VIRGINIA ELECTRIC AND POWER COMPANY  
RICHMOND, VIRGINIA 23261

June 25, 2007

Serial No. 07-0401  
NLOS/GDM R1  
Docket Nos. 50-280  
50-281  
License Nos. DPR-32  
DPR-37

**VIRGINIA ELECTRIC AND POWER COMPANY**  
**SURRY POWER STATION UNITS 1 AND 2**  
**PROPOSED LICENSE AMENDMENT REQUEST**  
**INCREASED MAXIMUM SERVICE WATER TEMPERATURE LIMIT**

**Figure 4: Proposed TS Figure 3.8-1 with Revised Containment Air Partial Pressure Upper Limits from 70°F to 100°F**

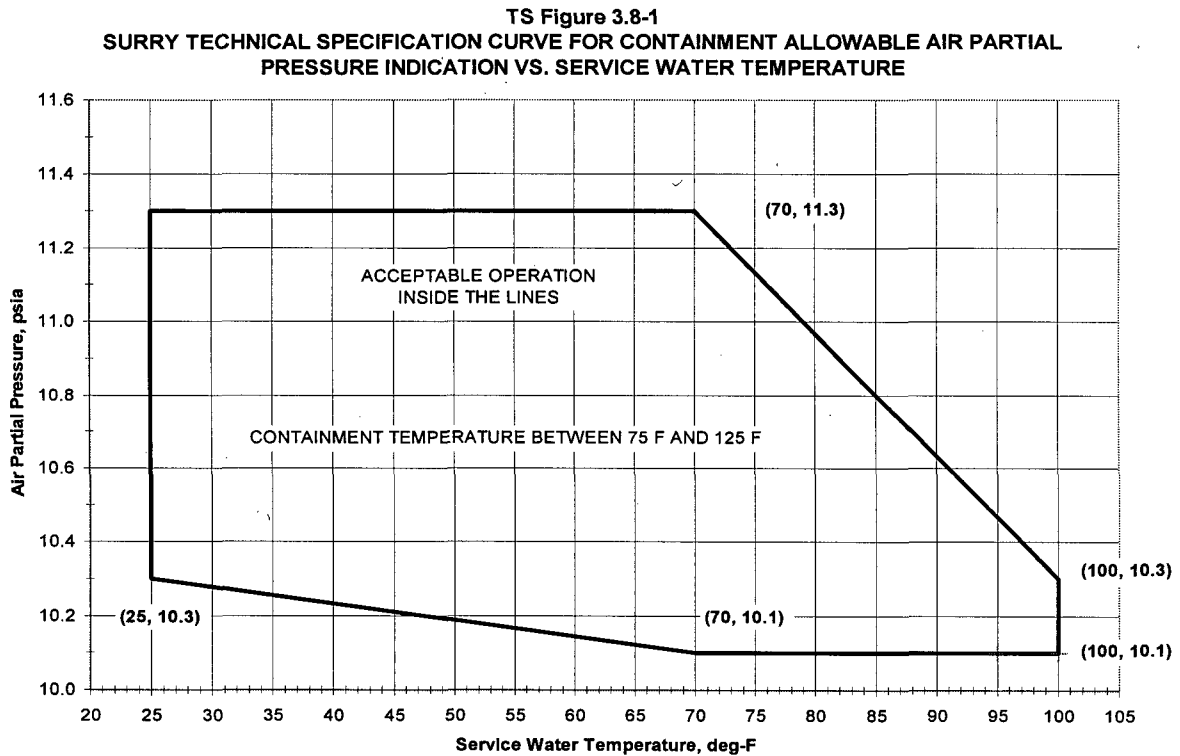
A proposed TS Figure 3.8-1 is included as Figure 4. The proposed change revises only the TS upper limit that extends from 11.3 psia containment air pressure at 70°F SW to 10.3 psia at 95°F SW. The proposed limit extends from 11.3 psia at 70°F SW to 10.3 psia at 100°F SW. Because the remaining limits in TS Figure 3.8-1 are not modified, the scope of analyses is limited to CDT and DPP analyses between 70°F and 100°F SW. Cases 1 and 2 in Table 3.4-1 of Attachment 1 of Reference 1 documented the results for the TS statepoint of 11.3 psia and 70°F SW. Those cases are not repeated. Cases 3 and 4 in that same table documented results for the TS statepoint of 10.3 psia and 95°F SW. Cases 3 and 4 are repeated in Tables 2 and 3 herein for comparison to the new design cases for a TS limit of 100°F SW.

The TS 3.8 containment air partial pressure limits of 10.1-10.3 psia at 95°F SW that were approved in Reference 2 can be shifted to 100°F with a small reduction in LOCA containment depressurization margin. Figure 4 documents the proposed TS Figure 3.8-1 with changes to the maximum containment air partial pressure limits from 70°F to 100°F SW and the minimum limit of 10.1 psia from 95°F to 100°F SW. GOTHIC containment analyses demonstrate that containment design criteria continue to be satisfied for these changes. The LOCA containment pressure profile is less than 1.0 psig from 1-4 hours and is subatmospheric after 4 hours, so the LOCA AST analysis in Reference 2 remains bounding. Further, the GOTHIC containment pressure and temperature profiles are within the analyzed limits for environmentally qualified equipment inside containment.

TS Figure 3.8-1

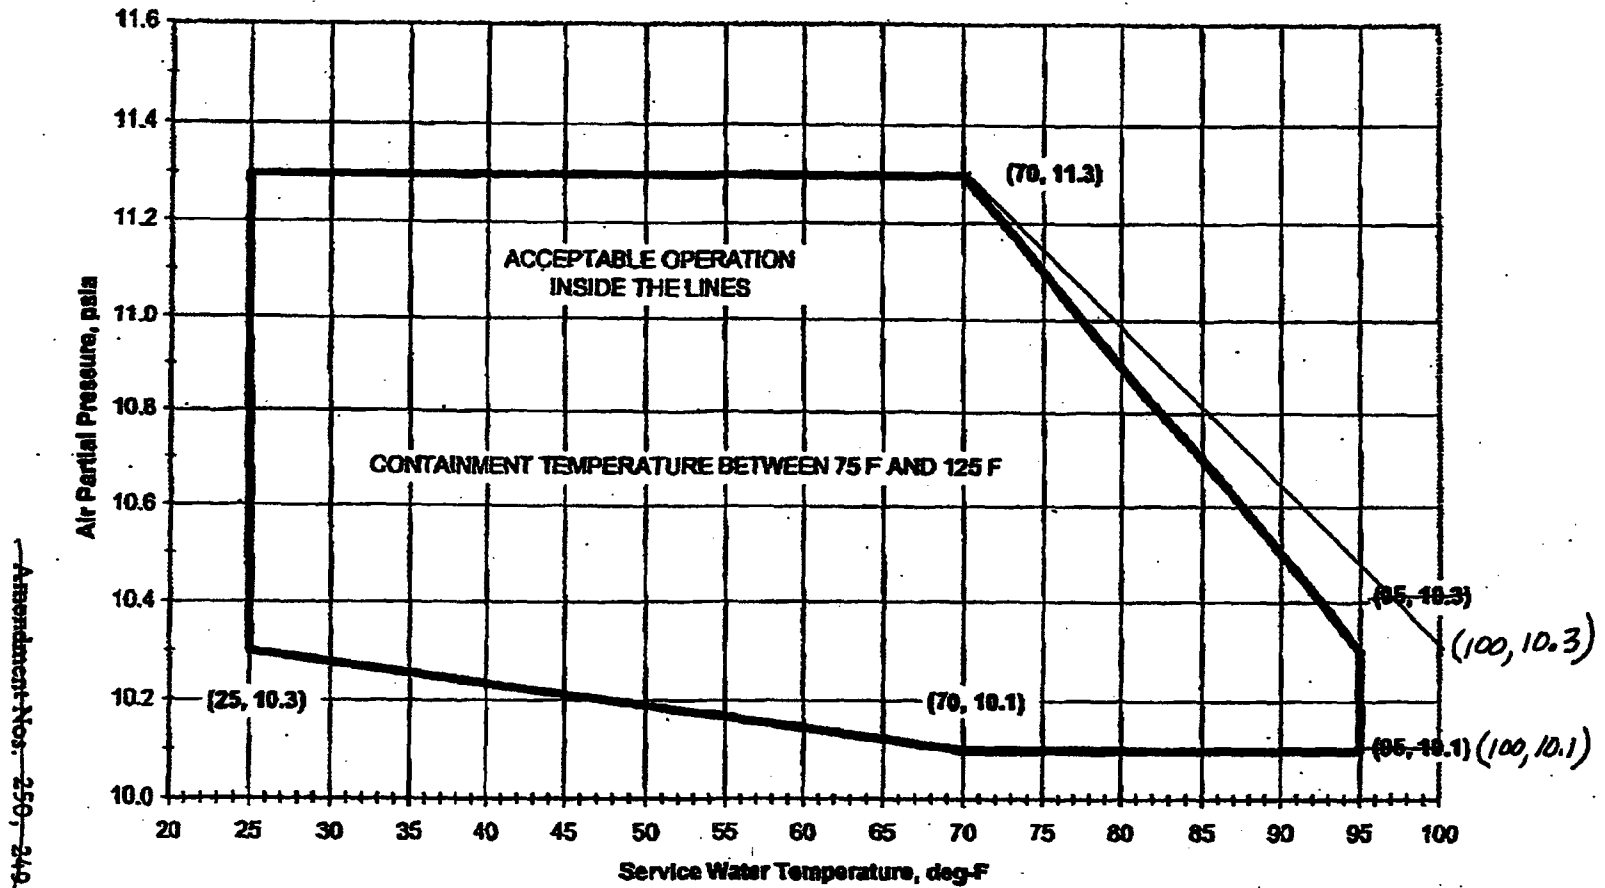
The allowable value for the containment air partial pressure is presented in TS Figure 3.8-1 for service water temperatures from 25 to <sup>100</sup>95°F. The RWST water shall have a maximum temperature of 45°F.

The horizontal upper limit line in TS Figure 3.8-1 is based on MSLB peak calculated pressure criteria, and the sloped line from 70°F to <sup>100</sup>95°F service water temperatures is based on LOCA depressurization criteria.

SURRY TECHNICAL SPECIFICATION CURVE FOR CONTAINMENT  
ALLOWABLE AIR PARTIAL PRESSURE INDICATION VS. SERVICE WATER TEMPERATURE

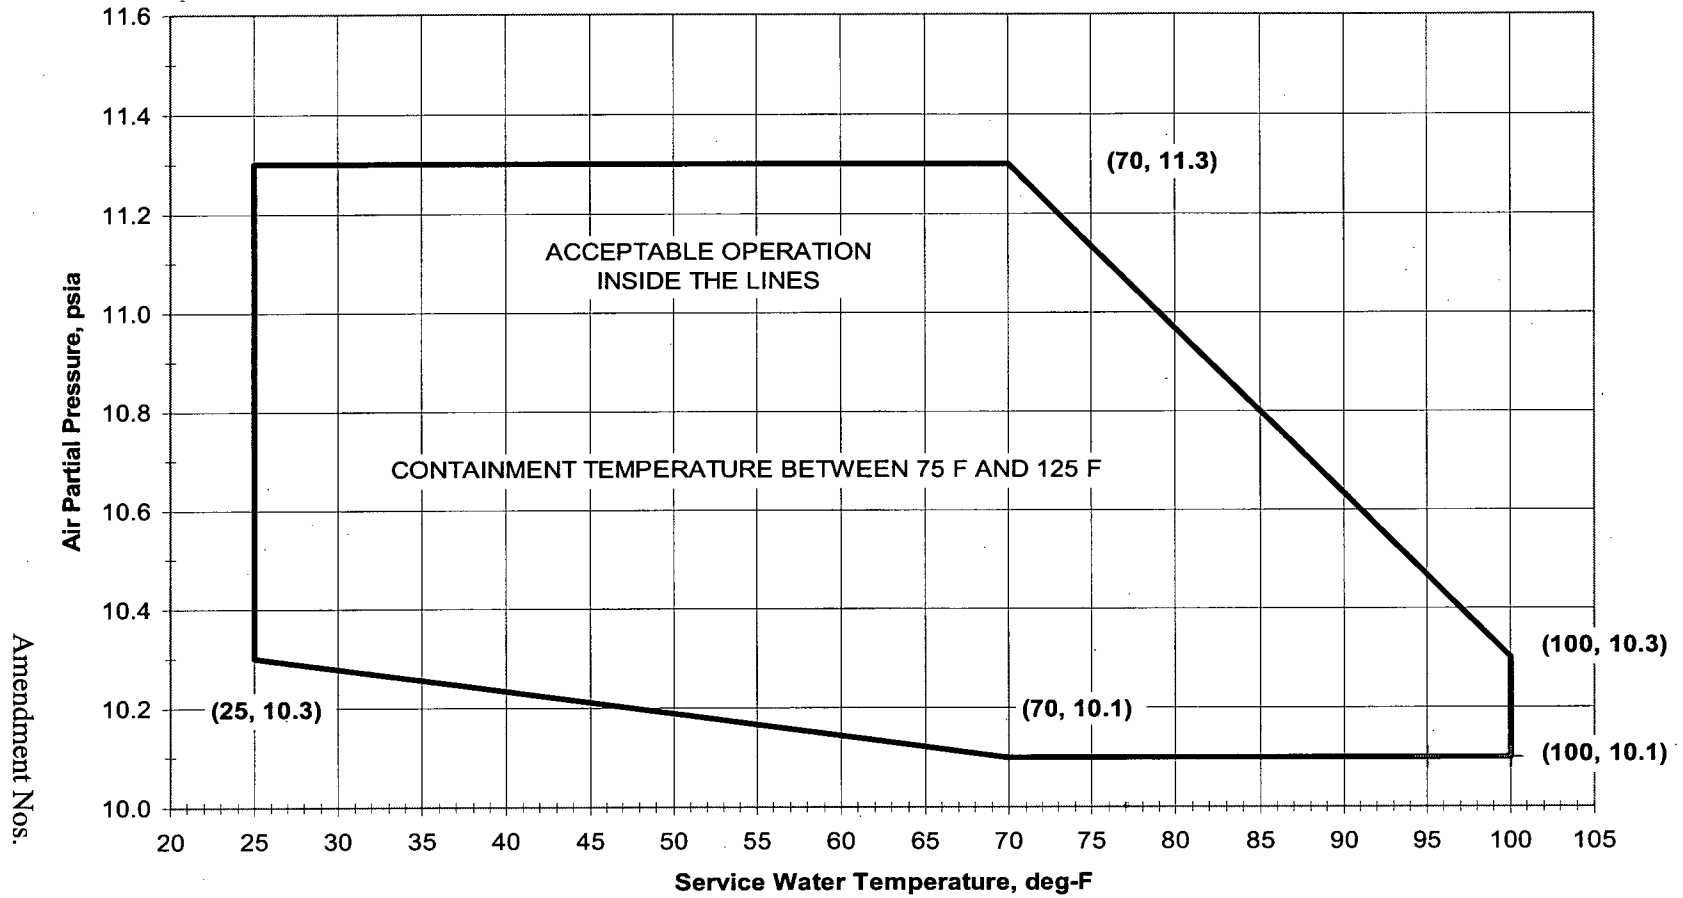
The allowable value for the containment air partial pressure is presented in TS Figure 3.8-1 for service water temperatures from 25 to 100°F. The RWST water shall have a maximum temperature of 45°F.

The horizontal upper limit line in TS Figure 3.8-1 is based on MSLB peak calculated pressure criteria, and the sloped line from 70°F to 100°F service water temperatures is based on LOCA depressurization criteria.
